Re: Osprey Landing

I have reviewed the application to have RP04N45E118401 subdivided into twelve (12) lots to be known as Osprey Landing and have determined the parcel and proposed lots are suitable for sub-surface waste disposal systems to serve residences. Each lot will be evaluated specifically when application is made by owner to install a septic system.

SUBDIVISION ON-SITE

TEST HOLE INFORMATION

Vicinity Map

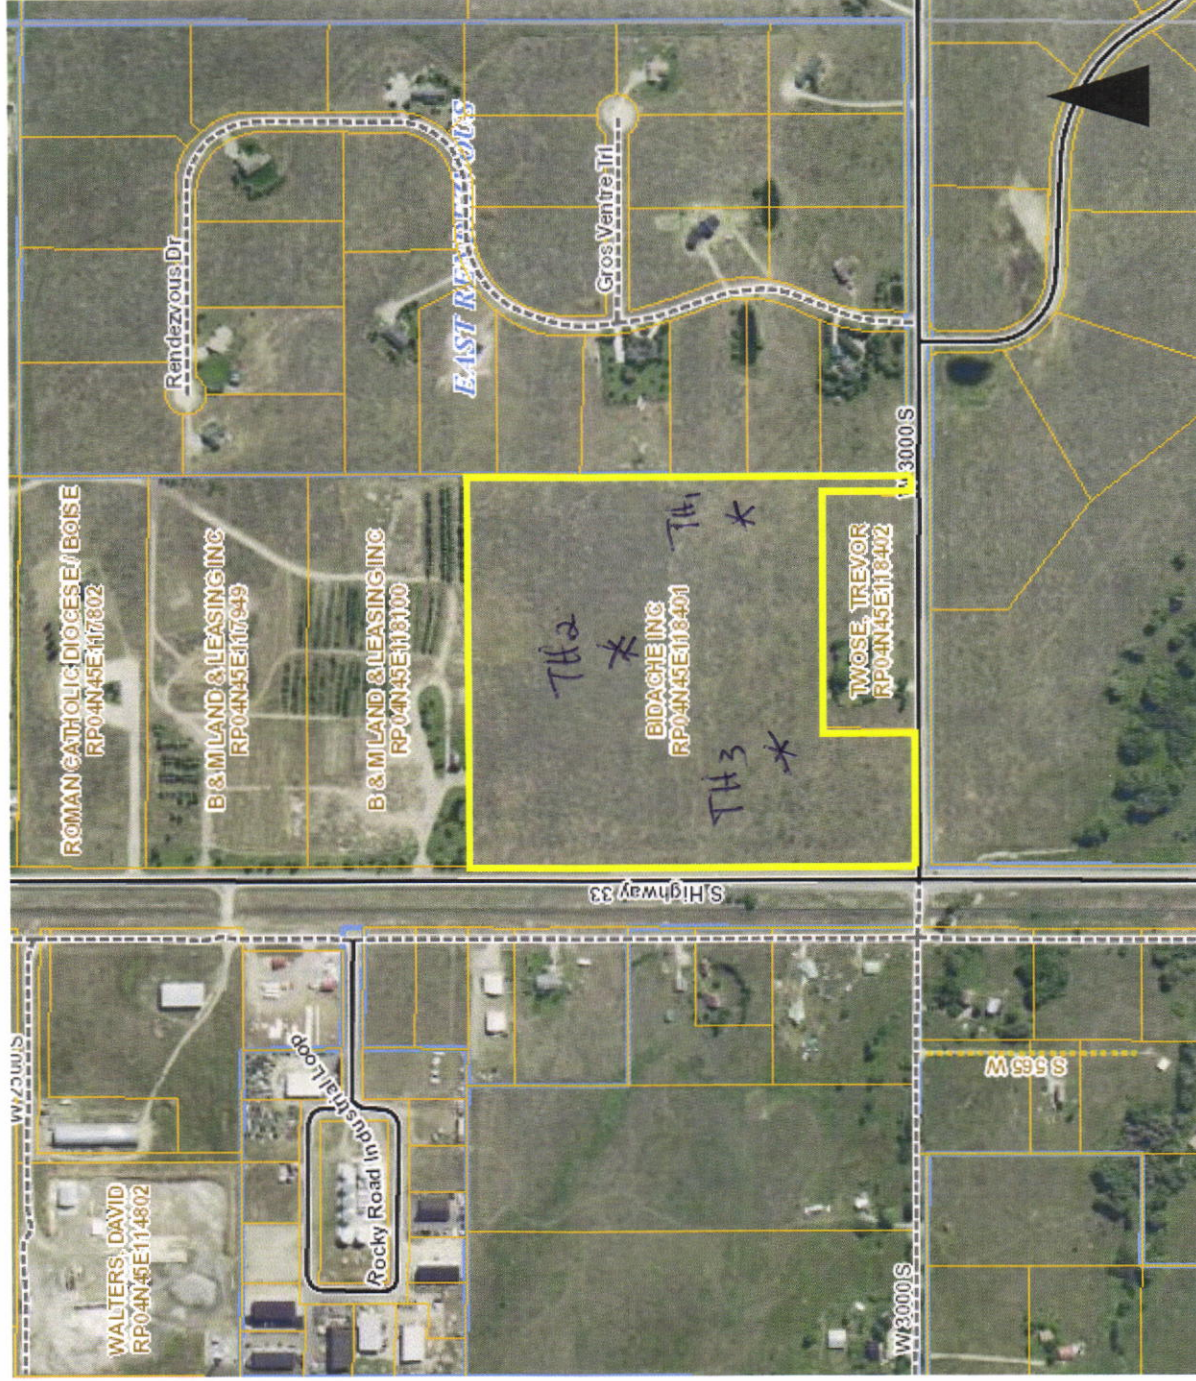
~ Test Hole Locations.

unable to produce.

Global Earth Map.

No internet available
